CALVERT CLIFFS  
NUCLEAR POWER PLANT

**SUBJECT:** Calvert Cliffs Nuclear Power Plant  
Unit No. 2; Docket No. 50-318  
Response to Request for Additional Information – License Amendment Request:  
One-Time Extension of the Containment Integrated Leak Rate Test Interval

**RESPONSE TO REQUEST FOR ADDITIONAL INFORMATION –  
ONE-TIME EXTENSION OF UNIT 2 CONTAINMENT INTEGRATED  
LEAK RATE TEST INTERVAL**

Figure 1

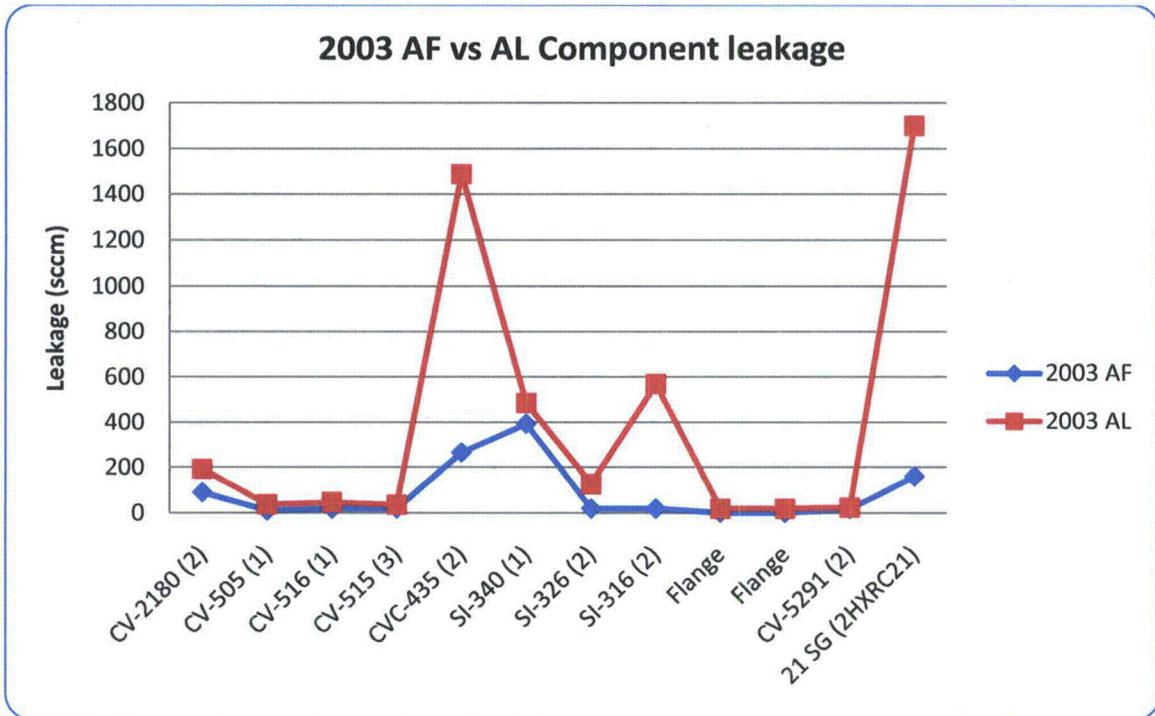
Section 3.5, Table 3.5.1 of Attachment 1 to the License Amendment Request provides a summary trend of Type B and C Local Leak Rate Test (LLRT) Combined As-Found/As-Left leakages for four refueling outages between the years 2003 and 2009. Please provide details explaining why the as left (AL) leakages are higher than as found (AF) leakages in the year 2003.

The primary contributors to higher 2003 AL leakage as compared to AF leakage are shown graphically in Figure 1 below:

The predominant contributors to this mismatch are seen in two Penetrations (2B and 21SG), with details regarding these as follows:

Penetration 2B (2CVC435) – Unit 2 check valve CVC435 was AF tested within administrative leakage limits during the 2003 Refueling Outage (RFO). Subsequently, the valve was replaced during the 2003 RFO with an equivalent approved EnerTech nozzle type check valve under a Calvert Cliffs work order. Subsequent AL testing of the new check valve resulted in a leakage rate of 1488 SCCM. This exceeded the administrative leakage limit of 296 SCCM, but was not in excess of the maximum limit of 10000 SCCM.

Penetration 21SG (21 SG South Manway) - 21 SG South Manway AF leakage rate was measured at 161.8 SCCM which was below the 2500 SCCM administrative leakage limit. During the 2003 RFO, Calvert Cliffs replaced Unit 2s steam generators. The manway covers were reinstalled on the newly replaced 21 Steam Generator and this manway penetration was AL tested SAT below the administrative leakage limit of 2500 SCCM at 1701 SCCM.

Subsequently, manways have been removed and reinstalled during the 2005, 2007, and 2009 RFOs for eddy current and visual inspections when necessary, and continue to remain within administrative leakage limits. The 2003 RFO AF versus AL leakage rate differences can be directly attributed to removal and reinstallation of the manway on the replacement steam generator.

Figure 2

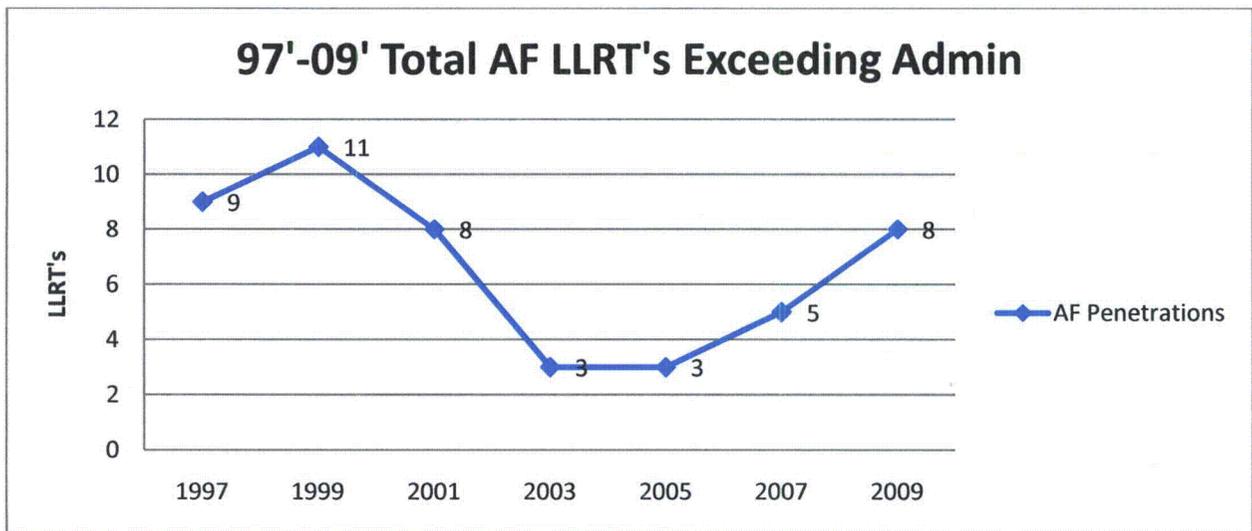
Section 3.5, Table 3.5.2 of Attachment 1 to the LAR provides a summary of AF LLRTs exceeding administrative limits. The table shows an increasing trend in the number of LLRTs exceeding administrative limits. Please provide details where they occurred and what has been done to fix the locations where the leakages have exceeded the admin limits. The staff would like to be assured that all negative trends are being properly addressed.

The number of AF LLRT results exceeding their administrative leakage limits are plotted below in Figure 2. This demonstrates there is no appreciable long term negative trend in the number of AF LLRT results exceeding their administrative leakage limits.
